RE: DRAINAGE PLAN SUBMITTAL OF HIDDEN VALLEY IV-A OFFSITE FLOW
PROTECTION, RECEIVED JUNE 10, 1986 FOR DRAINAGE
IMPROVEMENTS APPROVAL (L-22/D13)

RE: Hidden Valley Phase 4A

HIDDEN VALLEY REVISED CHANNEL DESIGN

Re: Hidden Valley IV Channel

CHUTE BLOCKS DETAIL

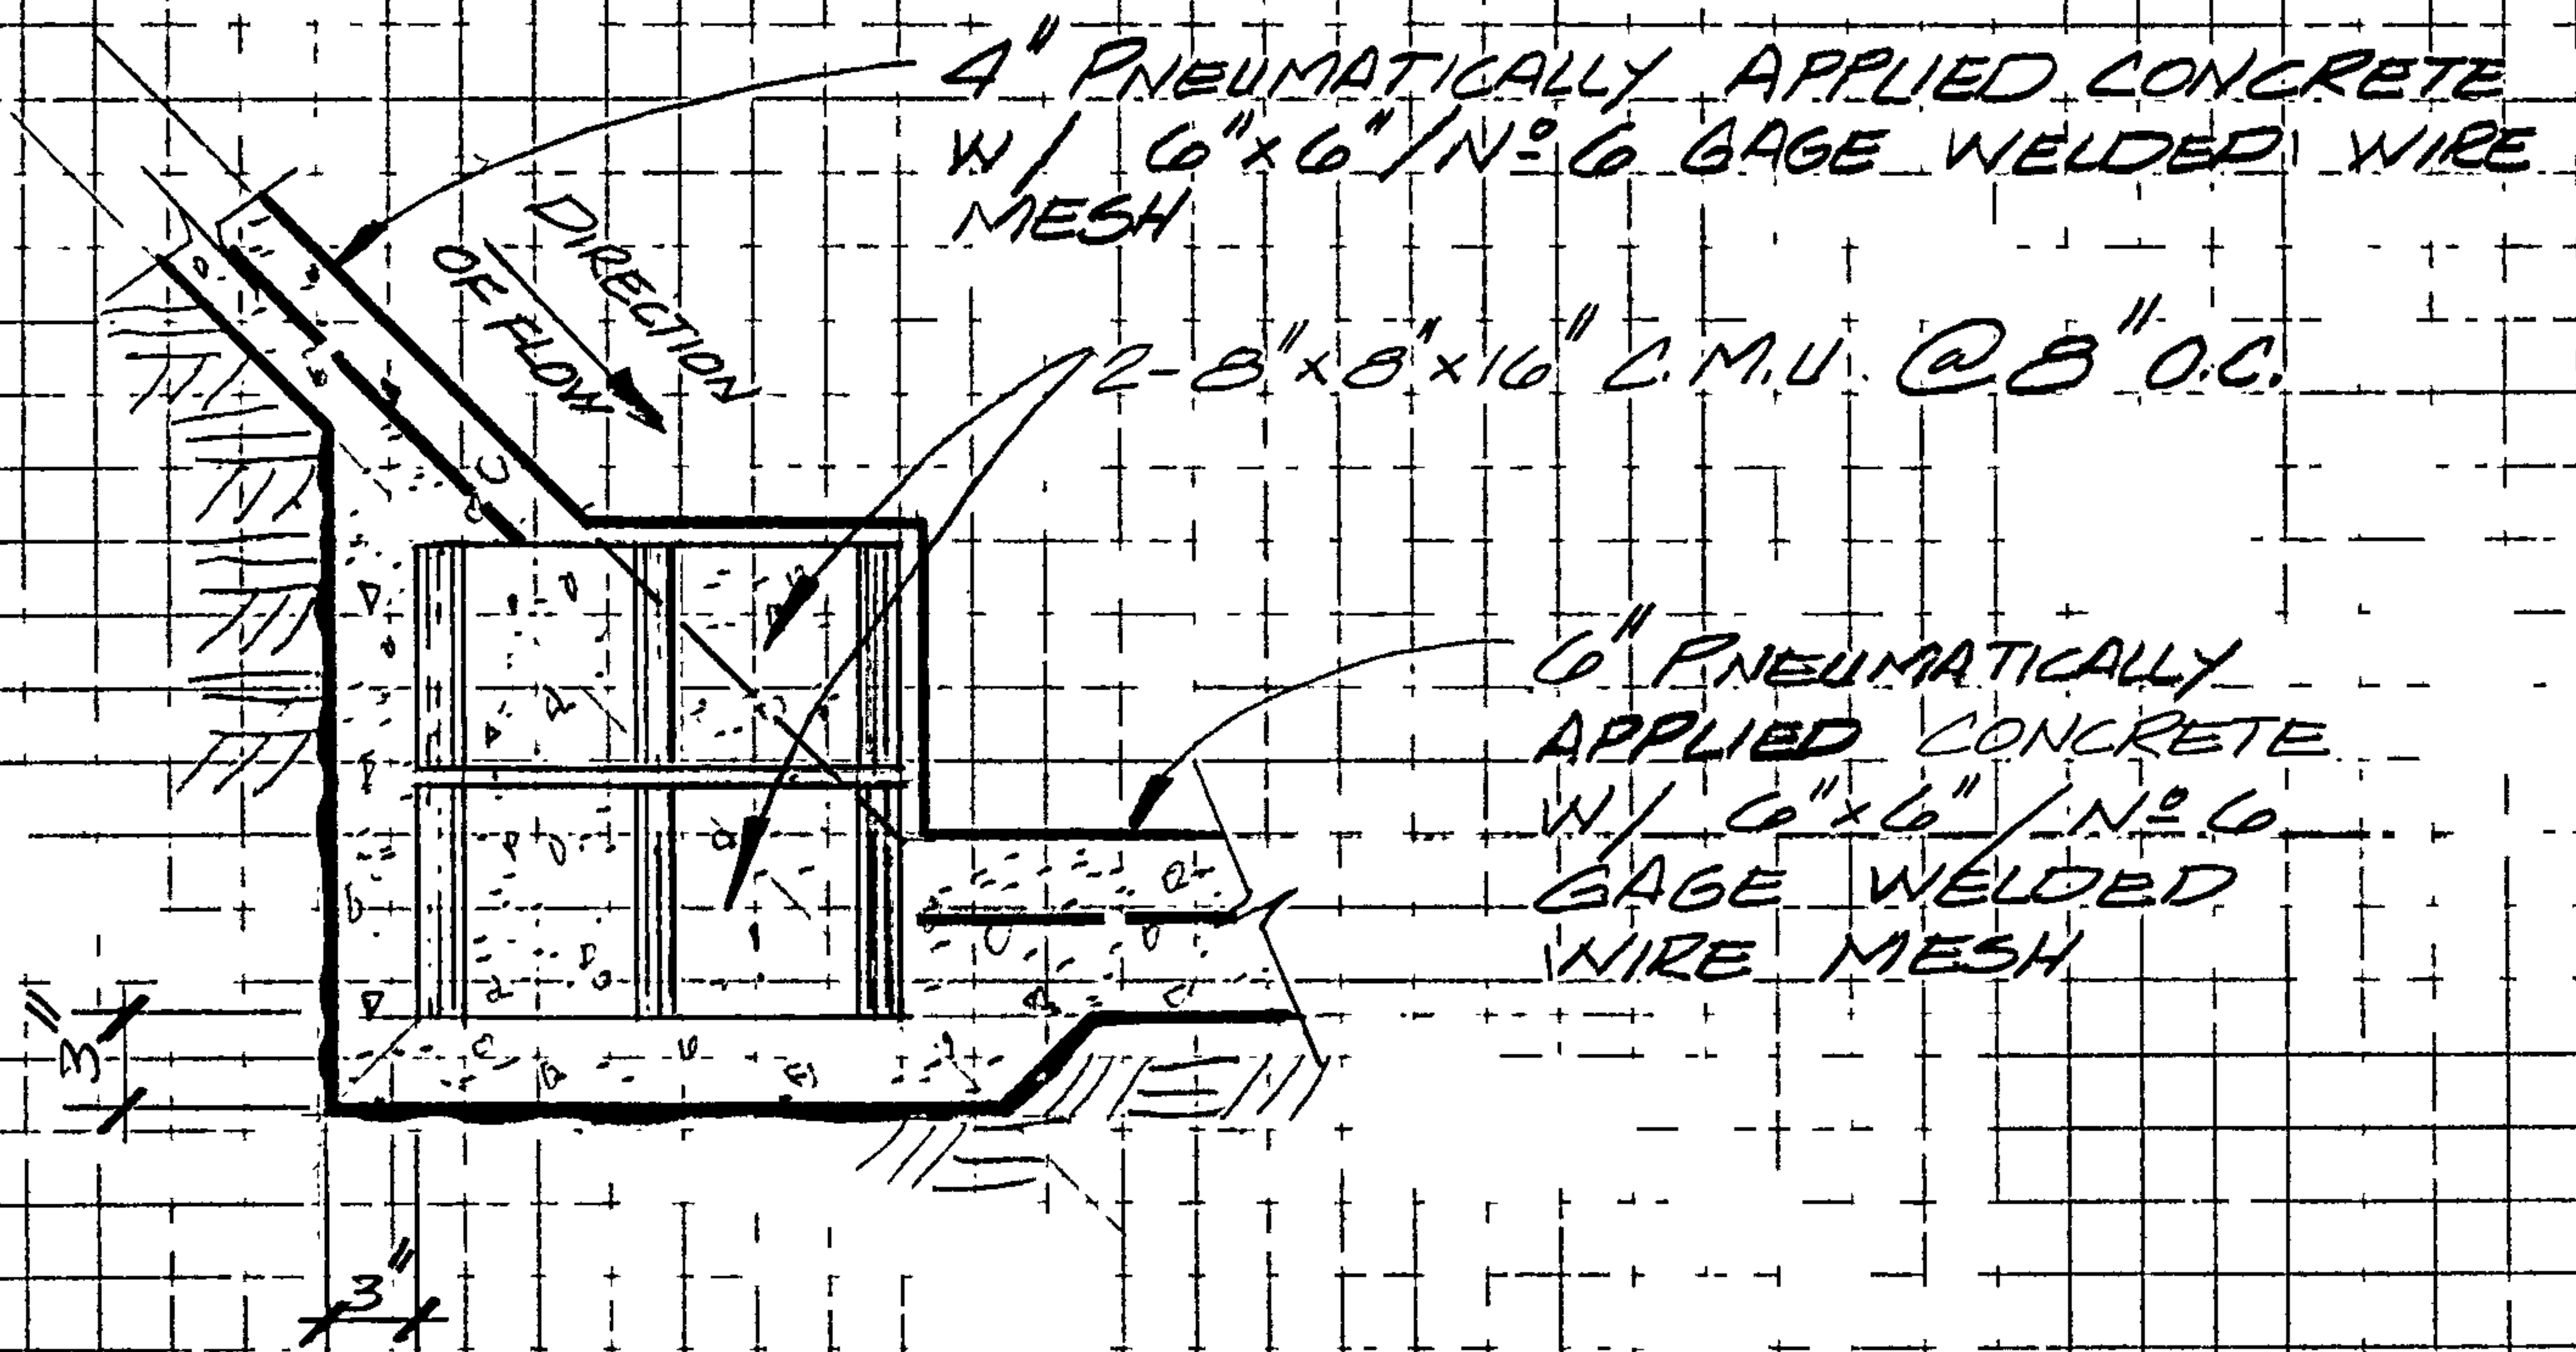
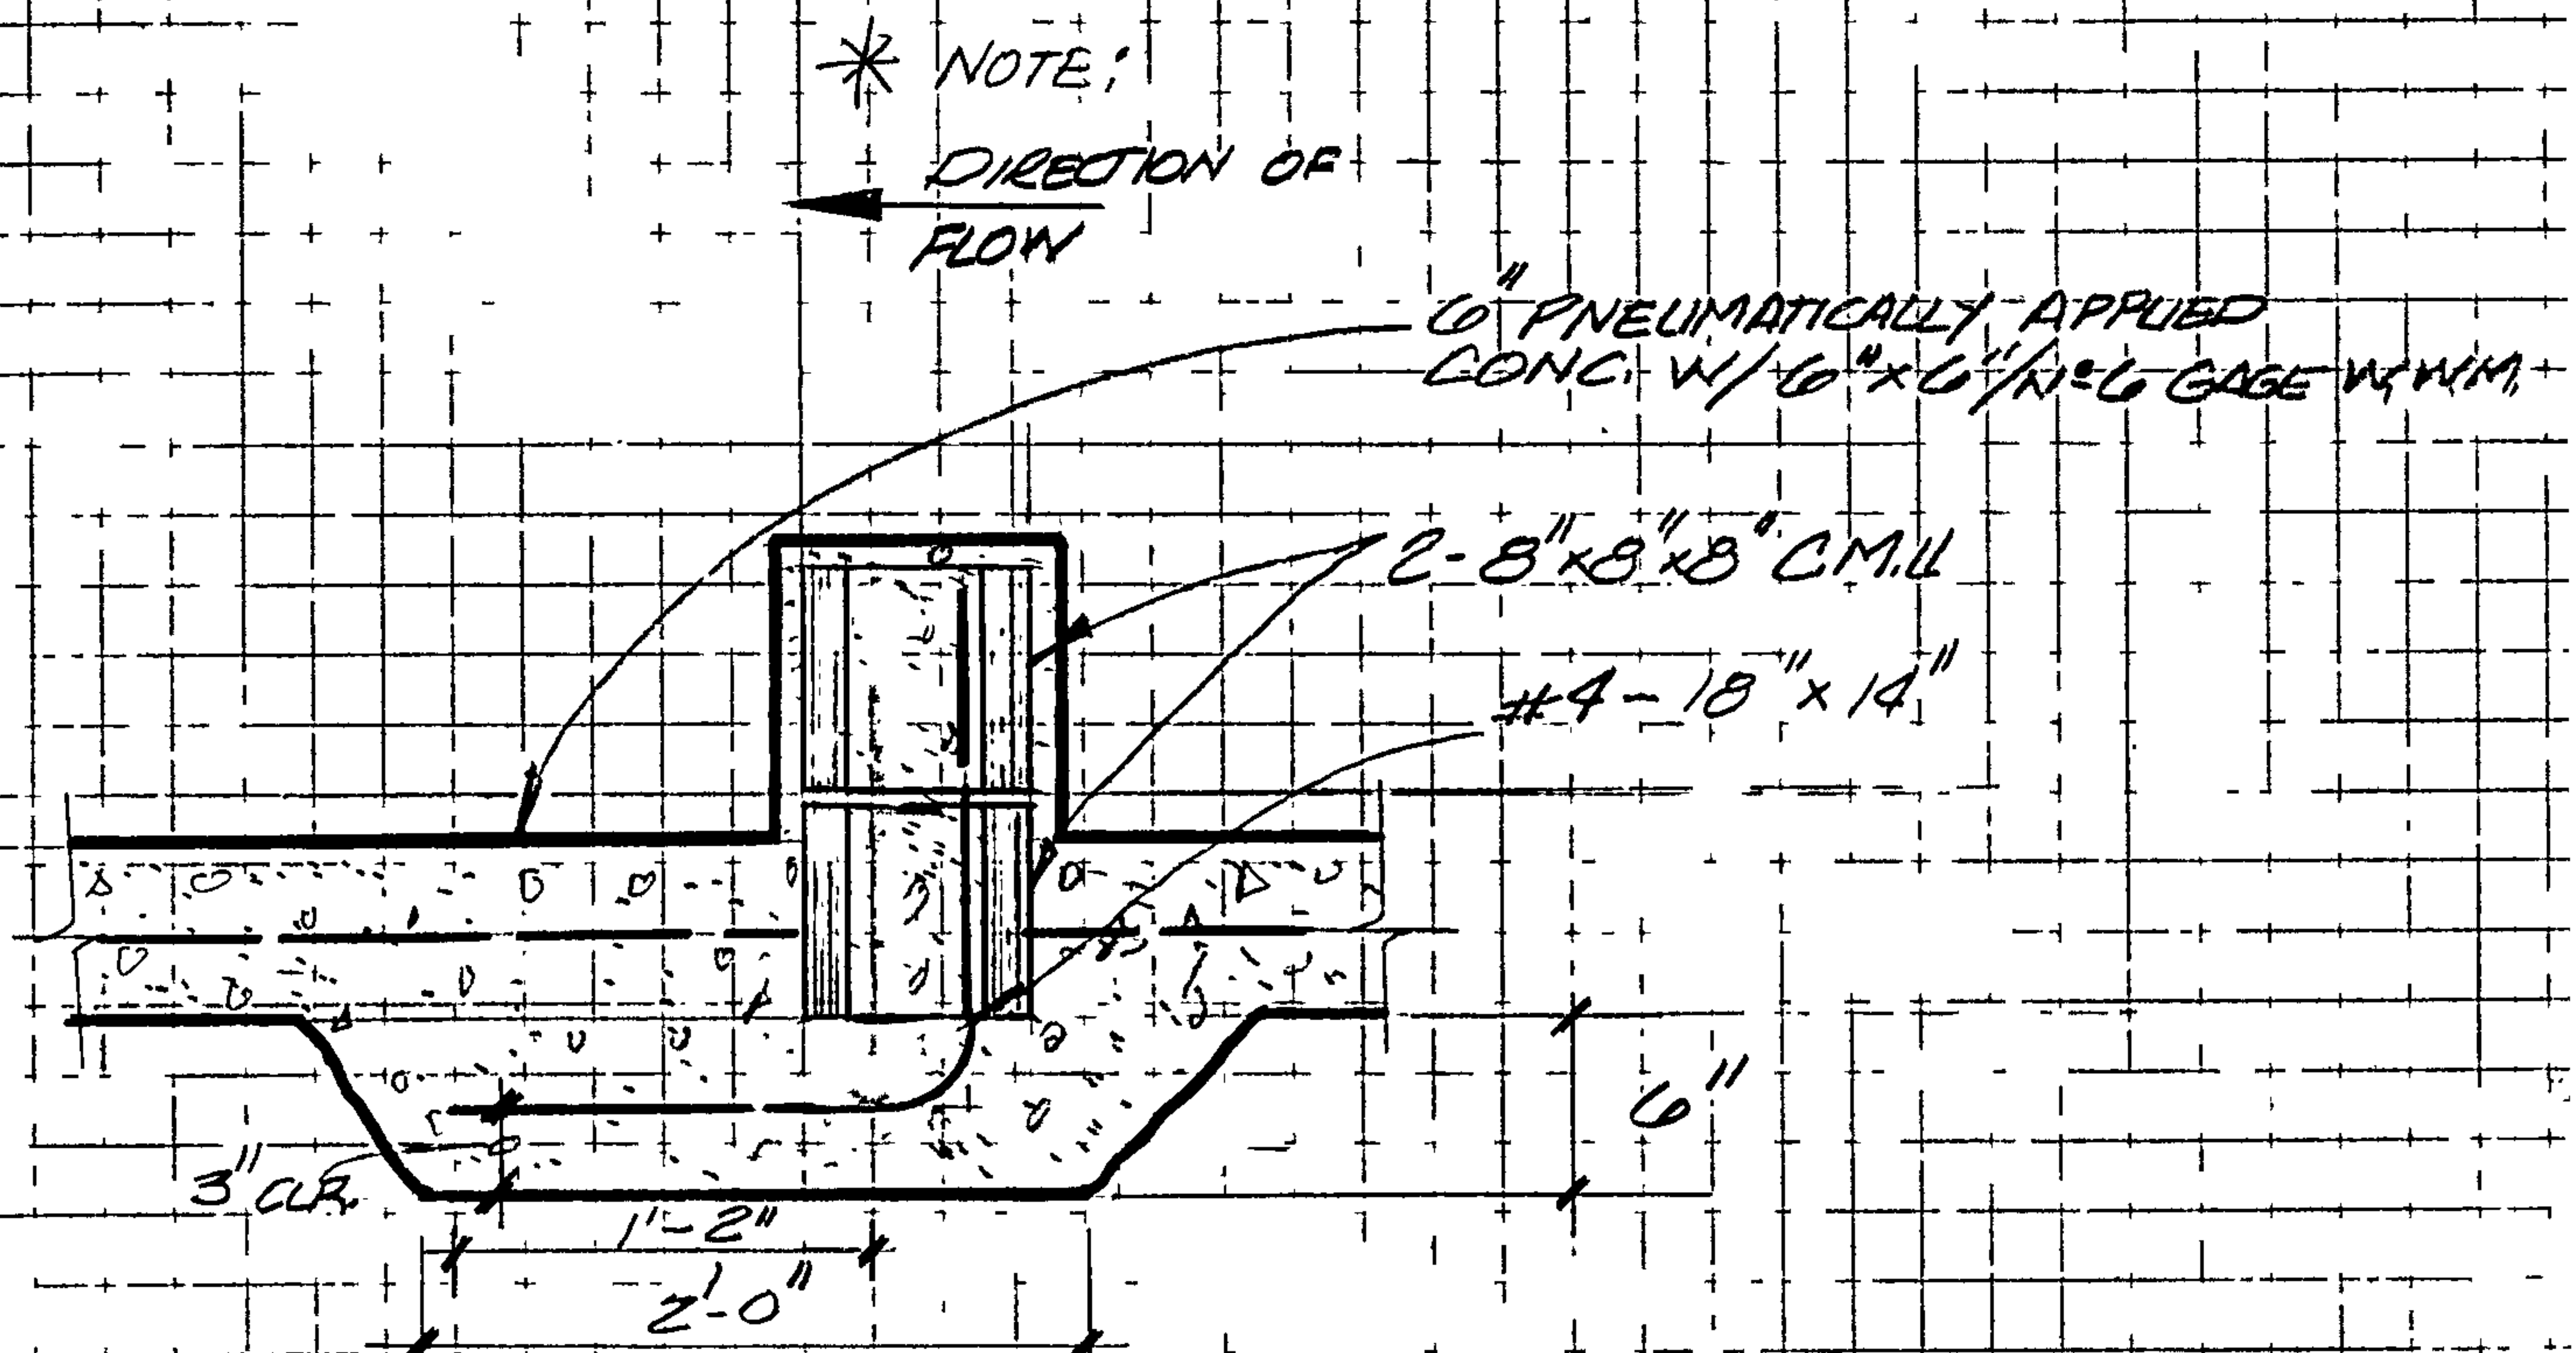
4. The flow down the chute needs to be laterally confined to insure the effectiveness of the baffle blocks. The cinder blocks embedded in the floor of the stilling basin would be receiving the impact of the flow travelling down the chute at 31.25 ft/sec. As such they receive the momentum of the water which must be transmitted to the reinforcing in the floor of the basin. The proposed solution is not acceptable.

5. A plannimetric representation of the stilling basin must be furnished to show that the chute blocks and the baffle blocks are offset as required in the design standards.
